SERVICE BULLETIN BS3086E

REFERENCE:	Nova Bus Manuals
SECTION:	09: Engine and accessories
RS Nº:	MQR 7621-273
EFFECTIVE IN PROD.:	L731 (2012DE)

SUBJECT:	Engine mount rubber isolators.
JUSTIFICATION:	Rubber isolators with a new design are now available.

Figure 6 - Engine Support Bolts

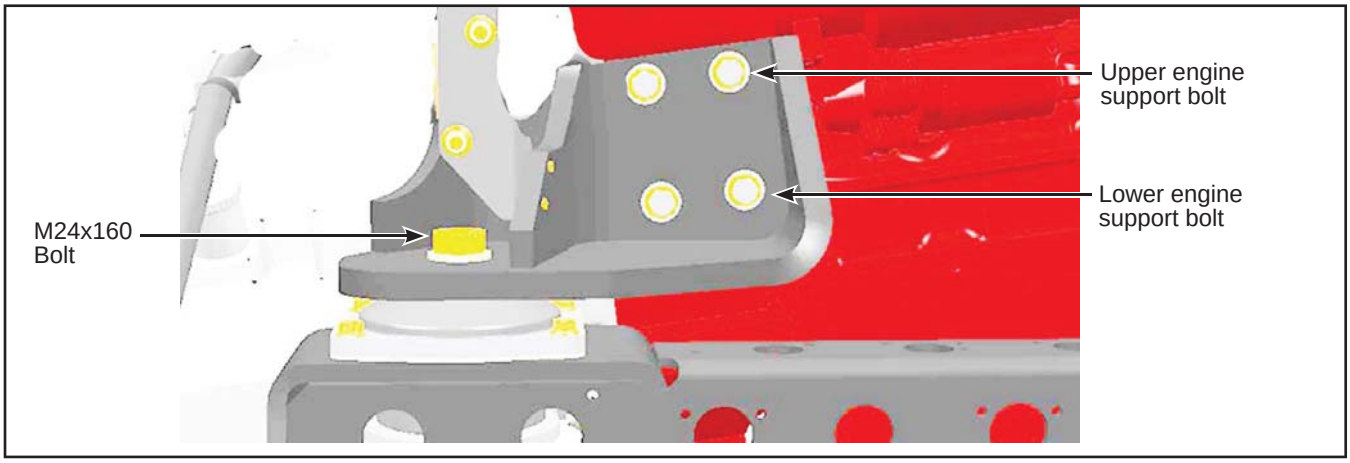
1.10. Remove and dispose of the four M16X45 bolts and lock washers of the engine support. See Figure 6.

Figure 7 - Isolator Installation

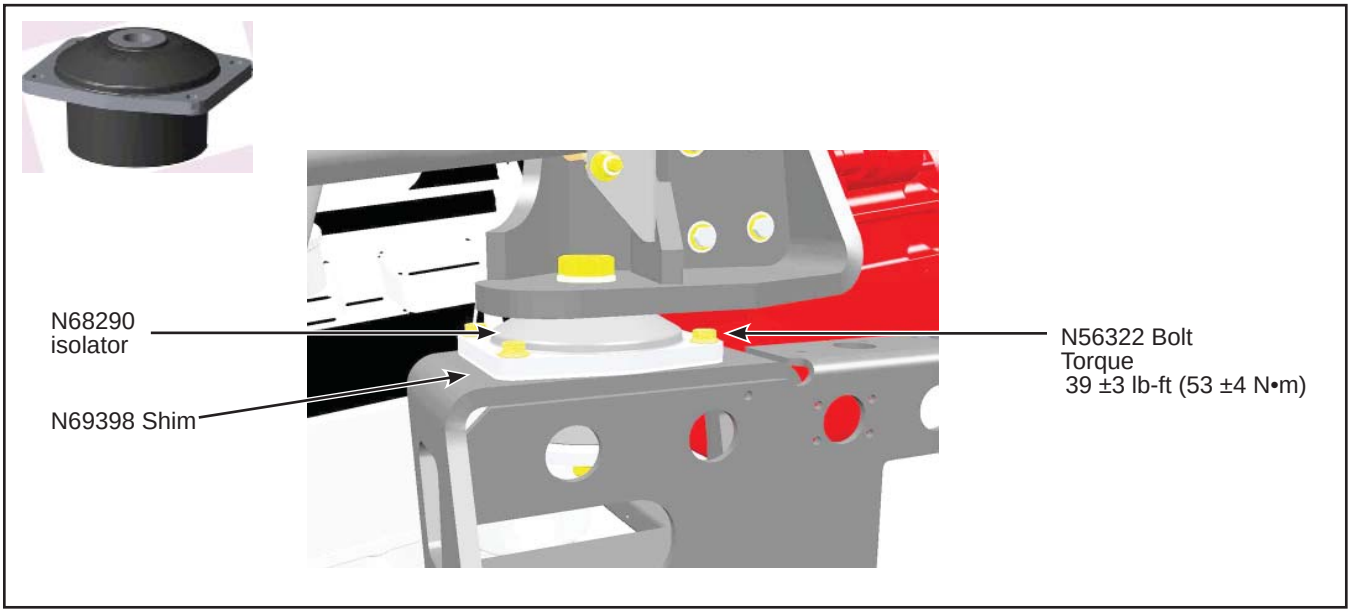
1.11. Remove and dispose of the four M10X45 bolts on each rubber mount.

1.12. Install an N69398 shim between the cradle and the rubber mount.

1.13. Install the new rubber isolator N68290 in it location.

1.14. Affix the new rubber isolator with four N56322 bolts. Tighten to the torque specified in Figure 7.

Figure 9 - Affixing Engine Support

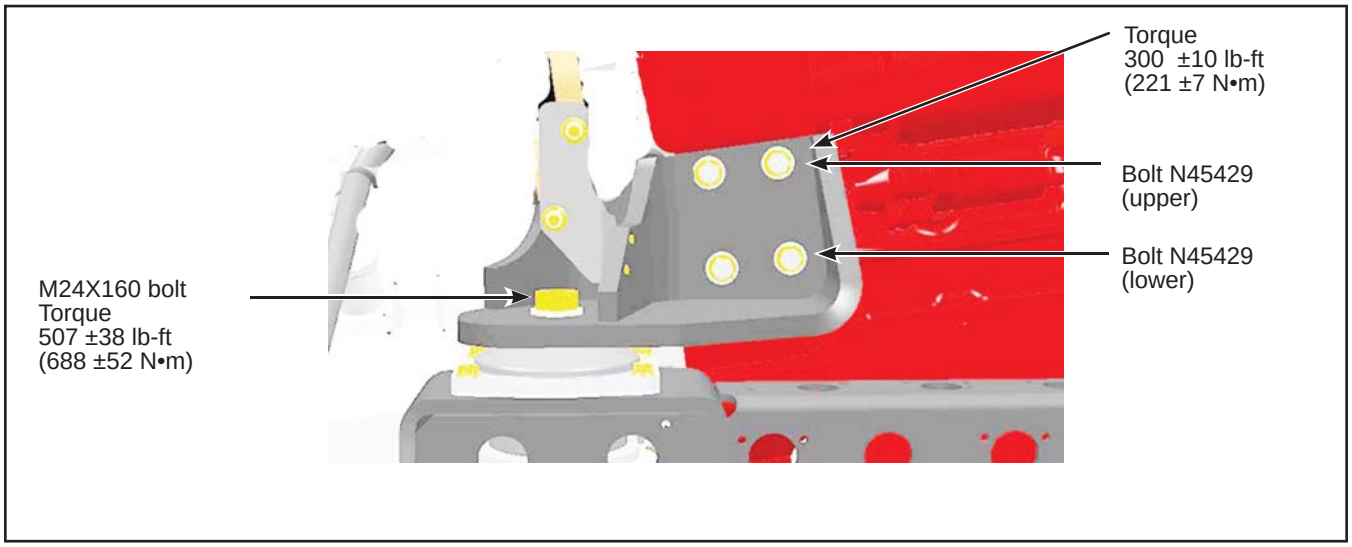
1.21. Affix the engine mount to the transmission fly wheel casing with four new N45429 bolts and N31667 lockwashers, Tighten to the torque indicated in Figure 9 . Do **NOT** use any thead-locker.

1.22. Install the retained M24X160 bolt and nut. Tighten to the torque indicated in Figure 9.

Figure 10 - Location of Rubber isolators

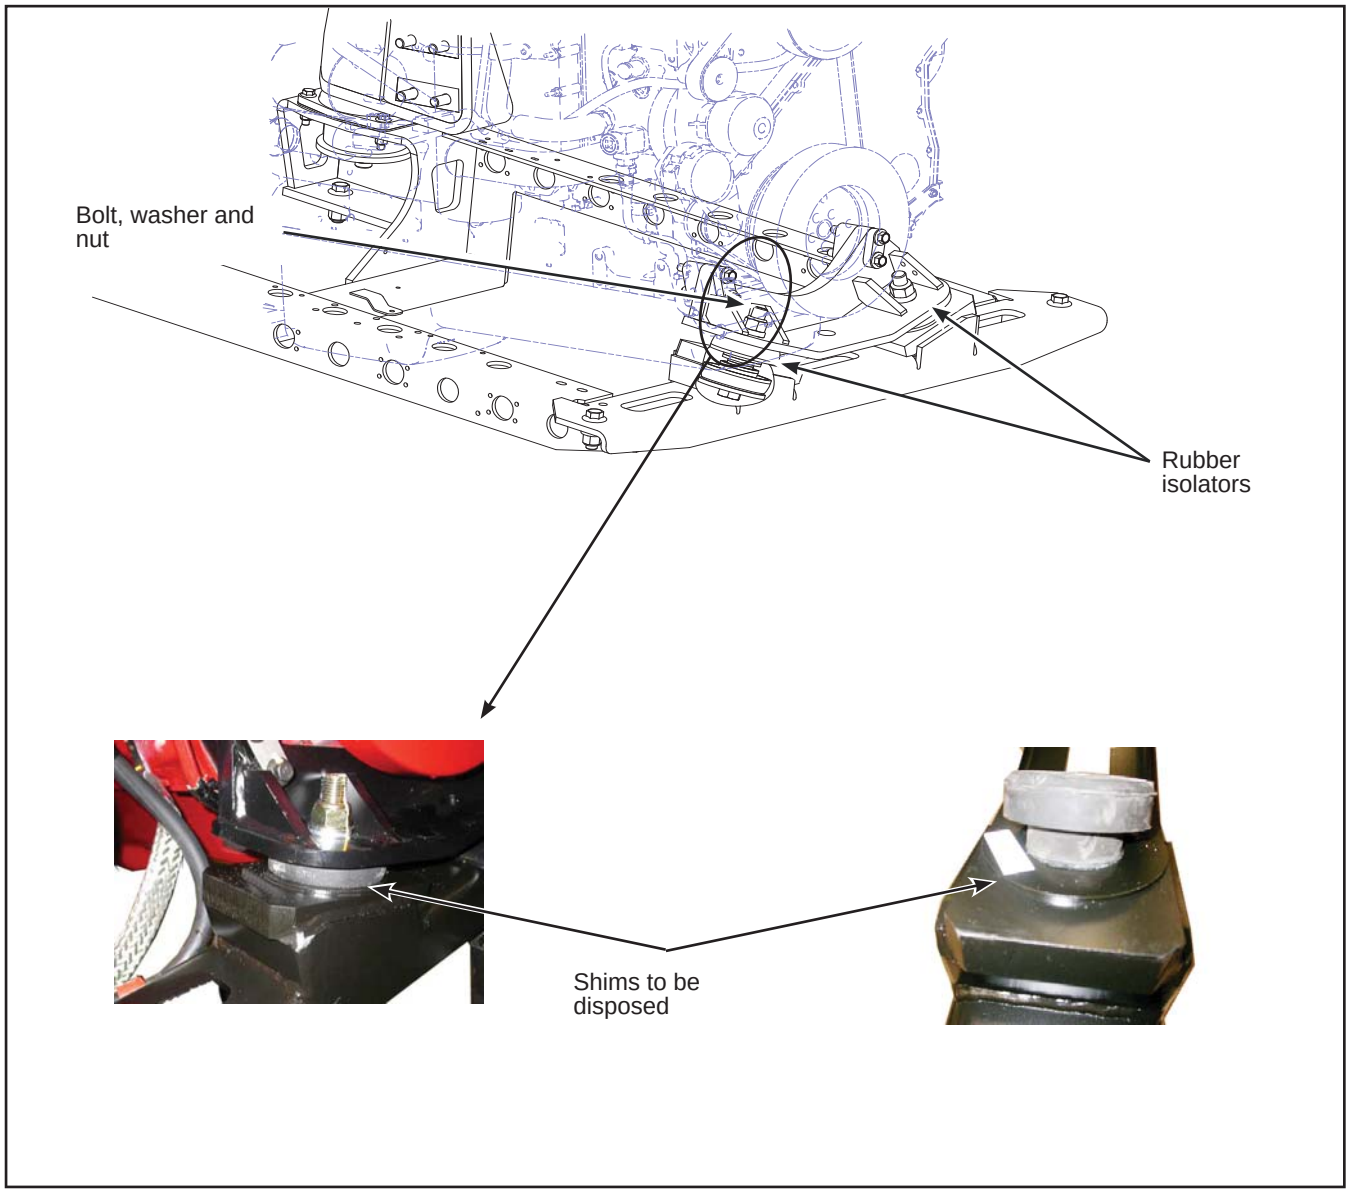
1.30. Remove the two bolts that retain the rubber isolators to the cradle. Retain the hardware. See Figure 10.

1.32. Remove the two rubber isolators from the cradle. See Figure 10.

1.33. If Shims are installed between the top part of the rubber isolator and the upper side of the cradle, dispose of this shim.

Figure 11 - Rubber Isolator Installation

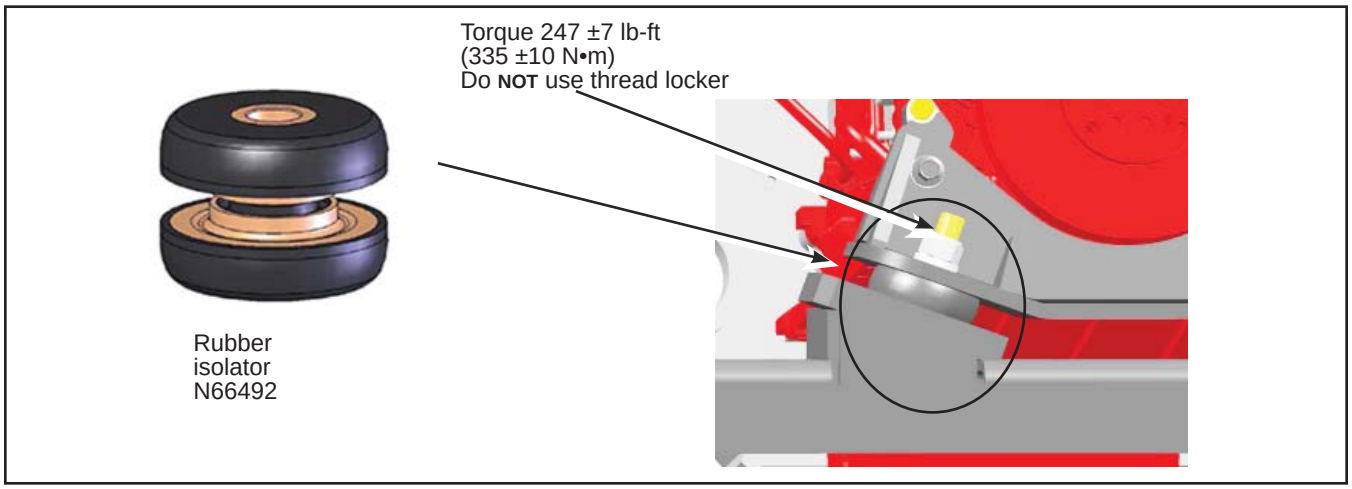
1.34. Install the two new N66492 rubber isolators.

1.36. Affix the rubber isolators with the retained hardware. Tighten to the torque specified in Figure 11.
